Technical Service Information

THM 350 ERRATIC CONVERTER CLUTCH

Figure 1

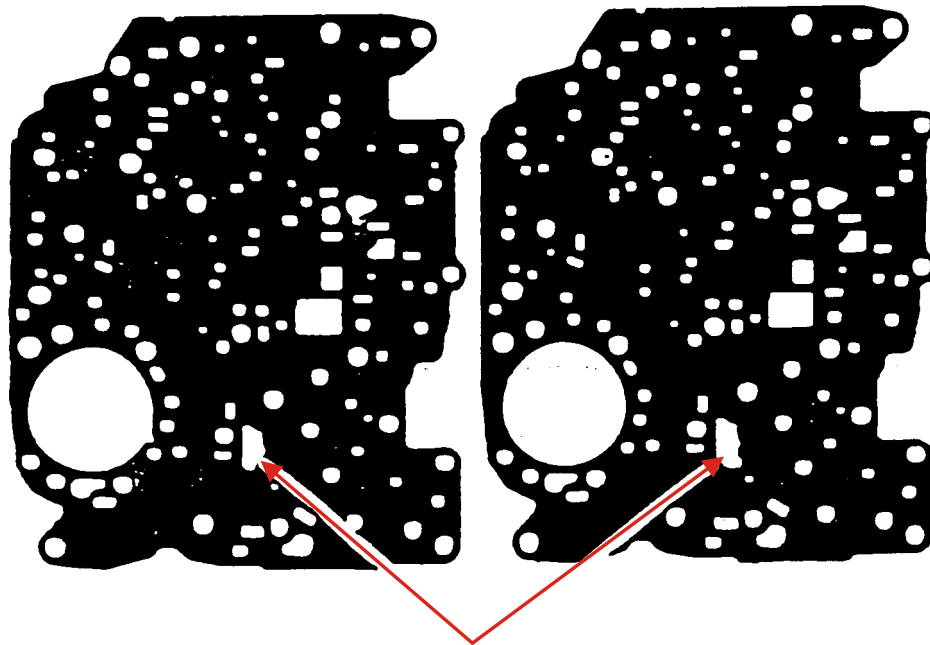
COMPLAINT: Erratic lockup of converter clutch, usually will lock up when Transmission is placed in drive or reverse, sometimes only when hot. May even let transmission lock up in third gear when the wire harness is disconnected. When hot the converter clutch may drag a little and give the engine a rough idle.

CAUSE: The cause may be a mis-matched gasket between the separator and the case. A mis-match of the separator to the case can also cause this problem-complaint. The illustration of the two gaskets or plates show the difference. The complaint will occur when a chevrolet gasket is used with an old-buick transmission case. However a buick gasket can be used on a chevrolet without any problem

NOTE GASKET CHANGES

CORRECTION: Always check the gasket and the plate when rebuilding a unit if a cross leak is noted where indicated on the gasket install proper gasket
